Arizona Public Service Company

Subject: Palo Verde Nuclear Generating Station (PVNGS)
Units 1, 2, & 3
Proposed Technical Specification Amendments to Specification 3/4.7.11, Shutdown Cooling System, to Delete the Auto-closure Interlock Surveillance of Surveillance Requirement 4.7.11b.
File: 91-004-419.05; 91-056-026

ATTACHMENT 1

Palo Verde Units 1, 2 & 3
Figure 1

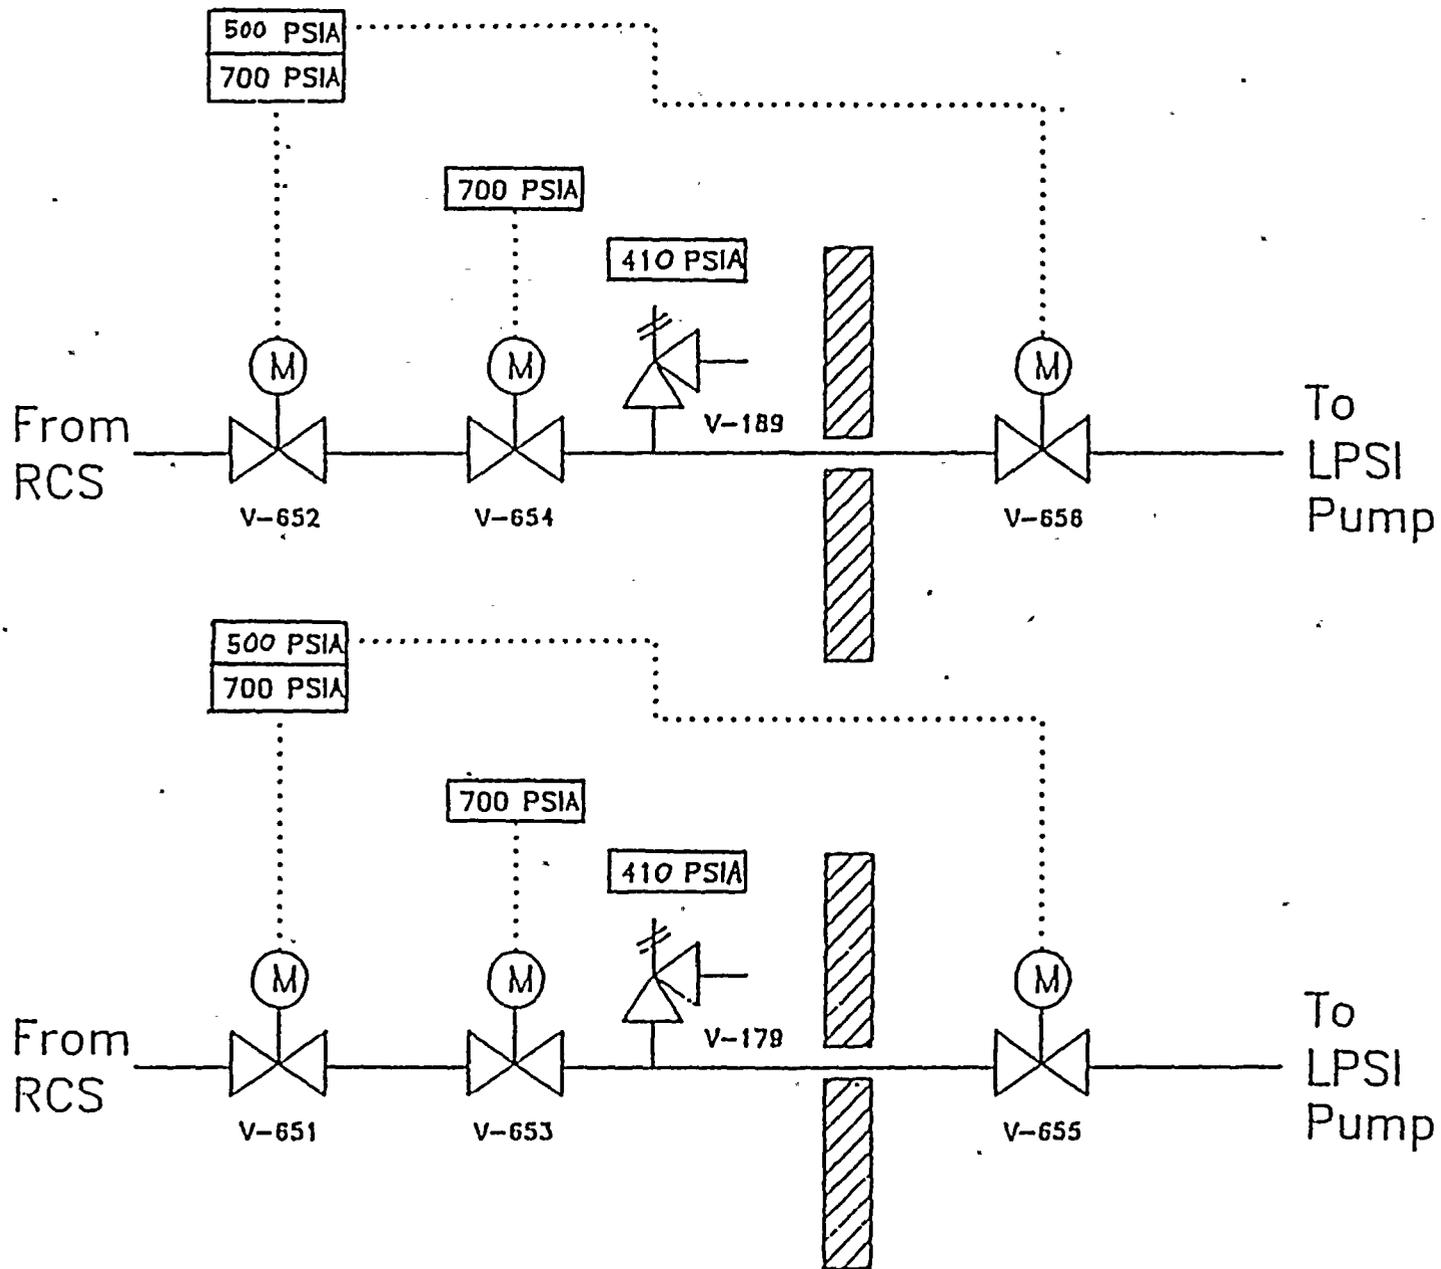
provided, each capable of maintaining the RCS pressure boundary with the other device failed. General Design Criteria 55 also requires that, when these lines penetrate the reactor containment, there must be at least one isolation device on each side of the containment boundary. Figure 1 on page 11 shows the SDCS suction line arrangement for PVNGS.

To guard against this, appropriate alarms and two instrumentation interlocks are used to reduce the probability of the inadvertent connection of the RCS to the SDCS when the RCS is pressurized. These interlocks are required by, and described in, NRC Branch Technical Position (BTP) 5-1. The first interlock is to prevent opening of the SDCS isolation valves when RCS pressure is above the SDCS design pressure. This feature is the OPI. It protects against the spectrum of events which result from the SDCS suction isolation valves being opened when the RCS is already pressurized. The proposed Technical Specification amendments do not change this interlock.

The second interlock automatically provides a close signal to the SDCS suction valves outside containment when RCS pressure exceeds 500 psia, while the SDCS suction valves located inside containment receive an automatic close signal when the RCS pressure is greater than 700 psia. Therefore, should these valves be inadvertently left open during RCS heatup and pressurization, the SDCS isolation valves would automatically close upon reaching a predetermined pressure

PVNGS employs six inch relief valves in the SDCS (one in each SDCS line) with sufficient capacity to mitigate LTOP events that may occur during shutdown cooling operations. These valves are located downstream of the SDCS suction valves inside containment. Because of their locations, inadvertent closure of the SDCS suction valves by ACI will isolate the relief valves and eliminate protection of the RCS piping if an LTOP event occurs.
